# Access Compliance Report

## Public Rights-of-Way

### (Curb Ramps)

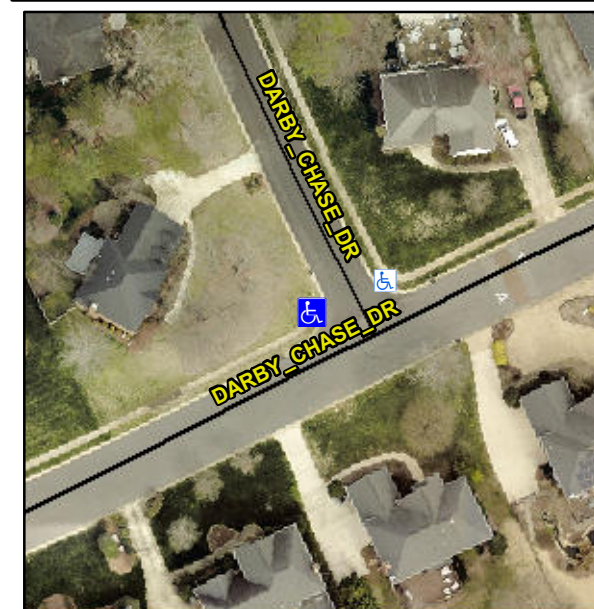
Intersection ID: 28233	Main Street: DARBY_CHASE_DR	Cross Street: N/A	Location: NW
ADA ID: 2A8B19AA23CD	Ramp Type: Perp	Initial Pass/Fail: Fail	Overall Compliance: No
Codes/Mitigation Info/Possible Solution		Field Measurements/Component Compliance

**Not Found, R304.2.2, R304.5.3**

Compliance	Description	Data	Compliance	Description	Data
N/A	Ramp Length (in)	94.0	No	Ramp Slope (%)	8.4
Yes	Ramp Width (in)	52.0	No	Ramp XSlope (%)	2.3
N/A	Flare Type LT	N/A	N/A	Flare Type RT	N/A
N/A	Flare Slope LT (%)	N/A	N/A	Flare Slope RT (%)	N/A
N/A	Flare Traversable LT?	N/A	N/A	Flare Traversable RT?	N/A
N/A	Landing Length (in)	N/A	N/A	DWS Provided?	N/A
N/A	Landing Width (in)	N/A	N/A	DWS Contrast?	N/A
N/A	Landing Slope (%)	N/A	N/A	DWS Length (in)	N/A
N/A	Landing X Slope (%)	N/A	N/A	DWS Full Width?	N/A
N/A	Landing Curb? (Y/N)	N/A	N/A	DWS Offset (in)	N/A
N/A	Shared Landing?	N/A			
N/A	Gutter Ponding?	N/A	N/A	Gutter Slope (%)	N/A
N/A	Gutter Lip Ht (in)	N/A	N/A	Gutter X Slope (%)	N/A
N/A	Painted X Walk1?	No	N/A	Painted X Walk2?	N/A
	X Walk 1 Direction	To NE		X Walk 2 Direction	N/A
N/A	X Walk 1 Width (in)	N/A	N/A	X Walk 2 Width (in)	N/A
	X Walk 1 Slope (%)	0.4		X Walk 2 Slope (%)	N/A
	X Walk 1 X Slope (%)	0.1		X Walk 2 X Slope (%)	N/A

**Remove & Replace Entire Ramp.**
